CROSS CREEK – MULTIFAMILY

Neighborhood 1, Map Area B

AMENDMENT #01 TO MASTER UTILITY STUDY

JULY 2021

Capacity Analysis (ORIGINAL MASTER REPORT CONDITIONS) - 6th Pkwy Sanitary Main

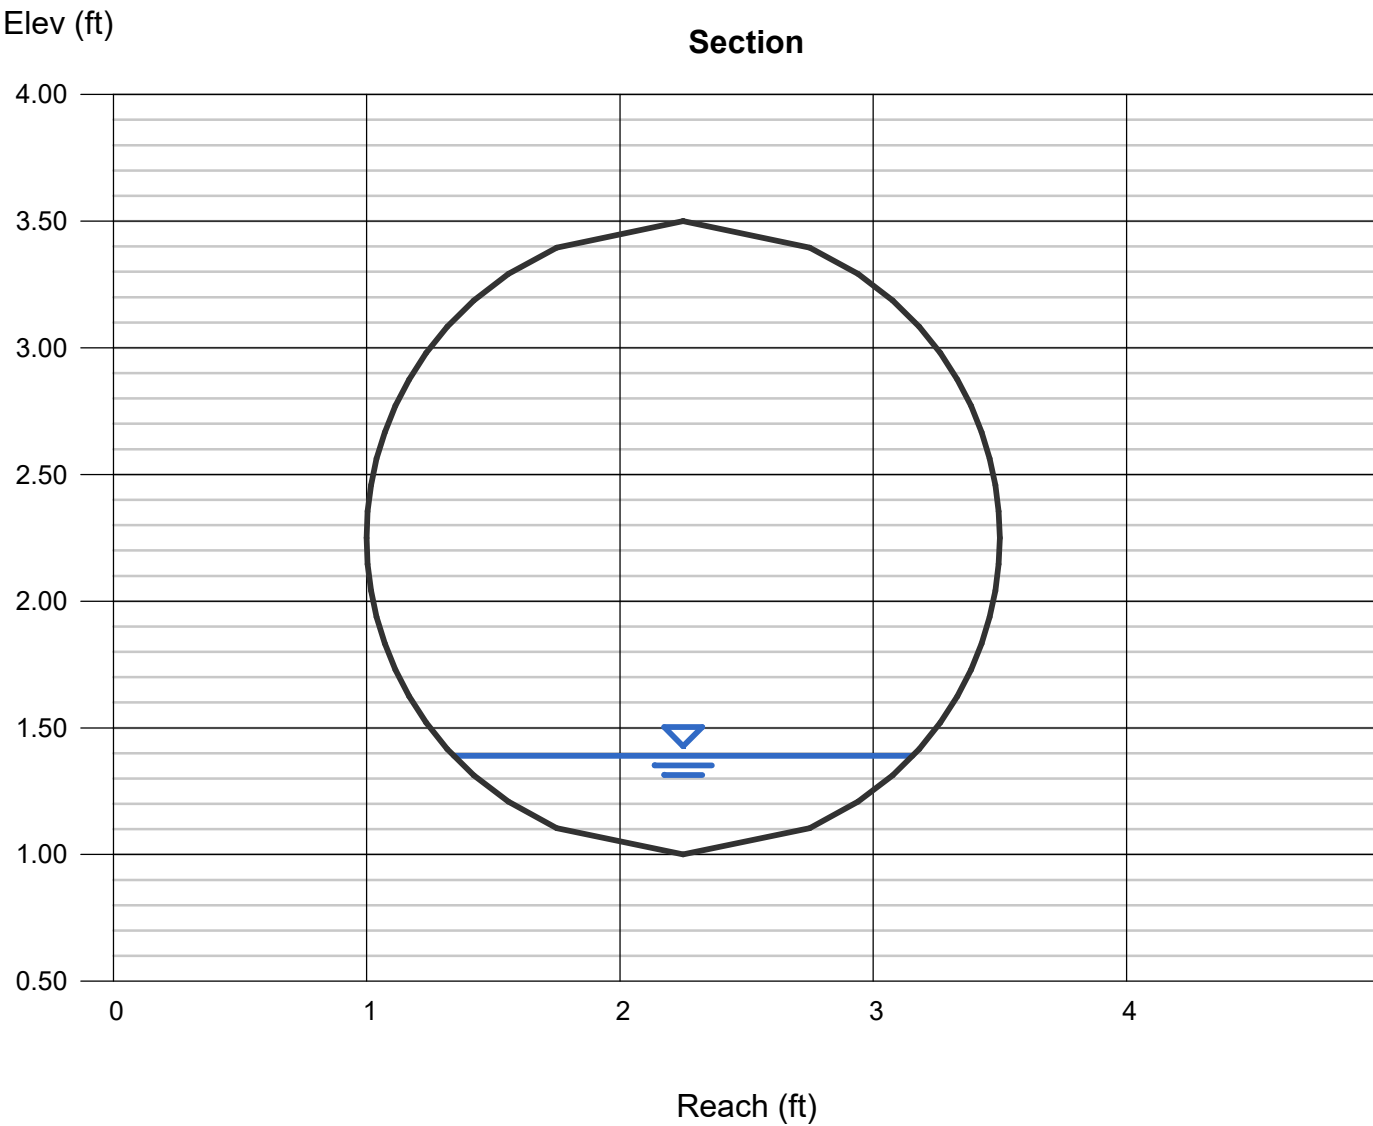
Provide circular worksheet
for 12 inch main in S
Catawba Way.

Capacity Analysis (PROPOSED REPORT AMENDMENT CONDITIONS) - 6th Pkwy Sanita

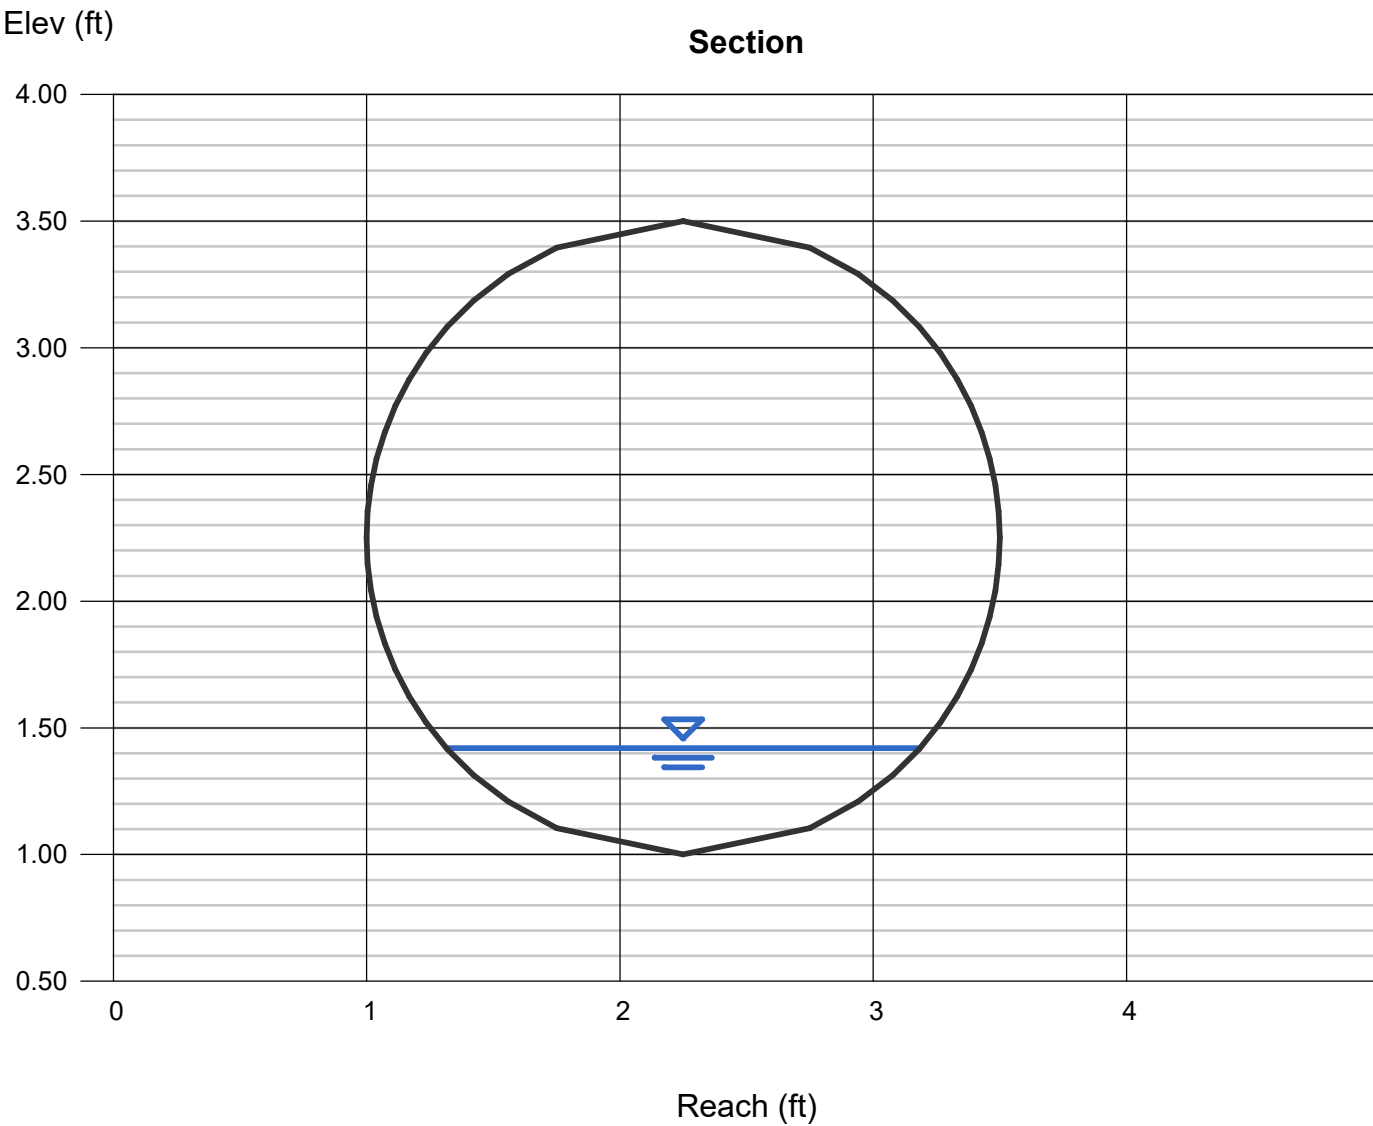
Update Q based on
calculation error
(typ on all relevant
model worksheets?)
